**Norme de fiabilité PRC-024-3 en suivi de
modifications
(version anglaise)**

PRC-024-3 is posted for a 10-day final ballot.

1. **Title:** ~~Generator Frequency and Voltage Protective Relay Settings for Generating Resources~~
2. **Number:** PRC-024-~~23~~
3. **Purpose:** ~~Ensure Generator Owners To~~ set ~~their generator protection~~ relays such that generating resource(s) units remain connected during defined frequency and voltage excursions in support of the Bulk Electric System (BES).
4. **Applicability:**

Figure 1

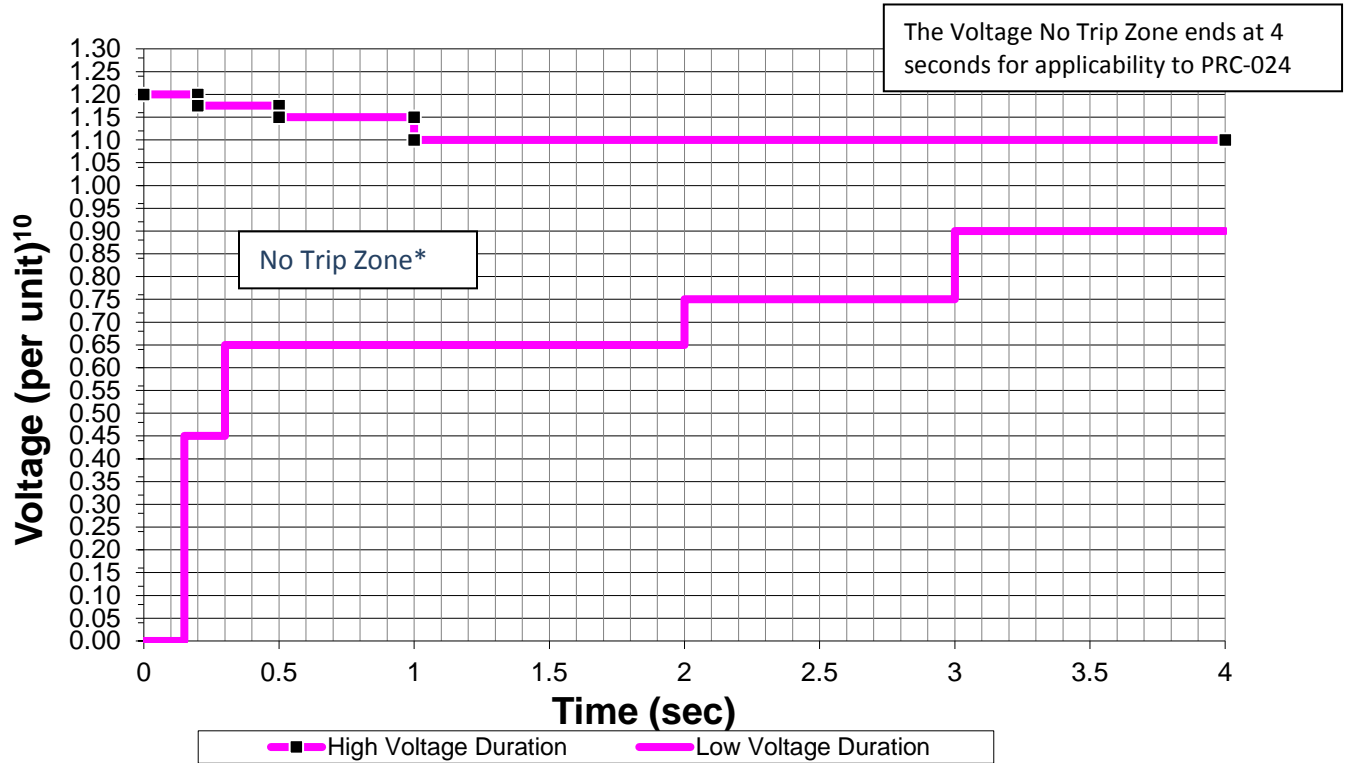
- ~~2. The curves depicted. The values in the table represent the minimum time durations allowed for specified voltage excursion thresholds.~~
- ~~4.3. When evaluating volts per hertz protection, either assume a system frequency is of 60 Hertz. When evaluating Volts/Hertz protection, you may adjust or the magnitude of the high voltage curve boundary can be adjusted in proportion to deviations of frequency below 60 Hz. Hertz.~~

- ~~5.4. Voltages in the curve boundaries assume minimum RMS fundamental frequency phase-to-ground or phase-to-phase voltage for the low voltage duration curve and the greater of maximum RMS or crest phase to phase voltage for the high voltage duration curve per unit voltage.~~

- ~~5. For applicability to PRC-024, the “no trip zone” ends at 4 seconds.~~

High Voltage Duration		Low Voltage Duration	
Voltage (pu)	Minimum Time (sec)	Voltage (pu)	Minimum Time (sec)
≥ 1.200	<u>0.00</u>	< 0.45	<u>0.15</u>
≥ 1.175	<u>0.20</u>	< 0.65	<u>0.30</u>
≥ 1.15	<u>0.50</u>	< 0.75	<u>2.00</u>
≥ 1.10	<u>1.00</u>	< 0.90	<u>3.00</u>
< 1.10	<u>4.00</u>	≥ 0.90	<u>4.00</u>

Figure 1

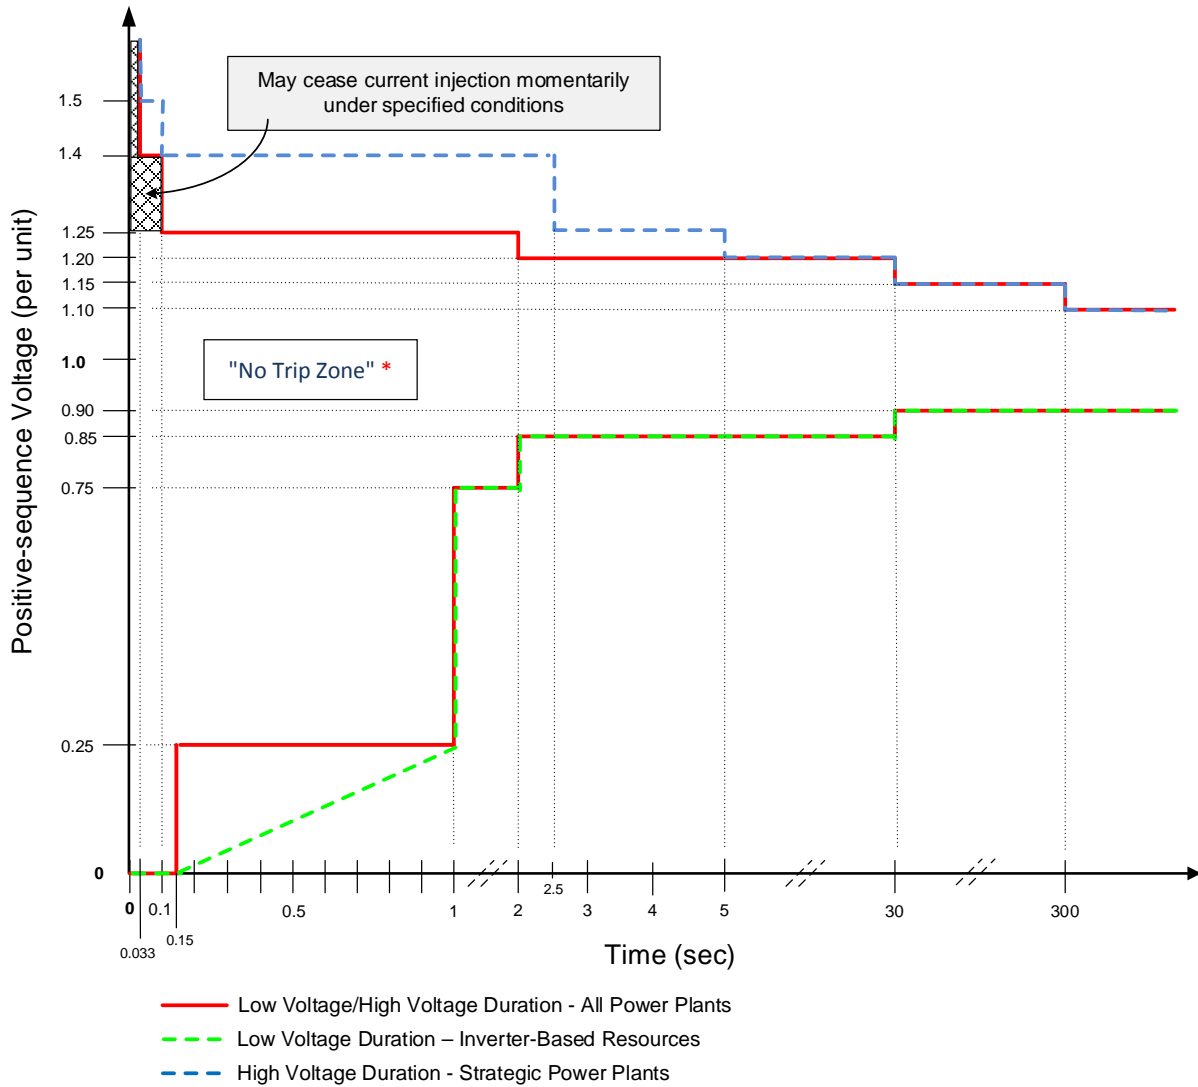
D.A.2. Each Generator Owner and Transmission Owner shall set its applicable voltage protection⁵ in accordance with PRC-024 Attachment 2a, such that the applicable protection does not cause the generating resource to trip or cease injecting current during a voltage excursion within the “no trip zone” at the high side of the GSU or MPT, subject to the following exceptions: [Violation Risk Factor: Medium] [Time Horizon: Long-term Planning]

<u>High Voltage Duration for all Power Plants</u>		<u>High Voltage Duration for strategic Power Plants</u>	
<u>Voltage (pu)</u>	<u>Minimum Time (sec)</u>	<u>Voltage (pu)</u>	<u>Minimum Time (sec)</u>
<u>---</u>	<u>---</u>	<u>>1.50</u>	<u>0.033</u>
<u>>1.40</u>	<u>0.033</u>	<u>>1.40</u>	<u>0.10</u>
<u>>1.25</u>	<u>0.10</u>	<u>>1.25</u>	<u>2.50</u>
<u>>1.20</u>	<u>2.00</u>	<u>>1.20</u>	<u>5.00</u>
<u>>1.15</u>	<u>30</u>	<u>>1.15</u>	<u>30</u>
<u>>1.10</u>	<u>300</u>	<u>>1.10</u>	<u>300</u>
<u>≤1.10</u>	<u>continuous</u>	<u>≤1.10</u>	<u>continuous</u>

<u>Low Voltage Duration for all Power Plants</u>		<u>Low Voltage Duration for Inverter-Based Resources</u>	
<u>Voltage (pu)</u>	<u>Minimum Time (sec)</u>	<u>Voltage (pu)</u>	<u>Minimum Time (sec)</u>
<u><0.25</u>	<u>0.15</u>	<u><0.25</u>	<u>3.4*V(pu)+0.15</u>
<u><0.75</u>	<u>1.00</u>	<u><0.75</u>	<u>1.00</u>
<u><0.85</u>	<u>2.00</u>	<u><0.85</u>	<u>2.00</u>
<u><0.90</u>	<u>30</u>	<u><0.90</u>	<u>30</u>
<u>≥0.90</u>	<u>continuous</u>	<u>≥0.90</u>	<u>continuous</u>
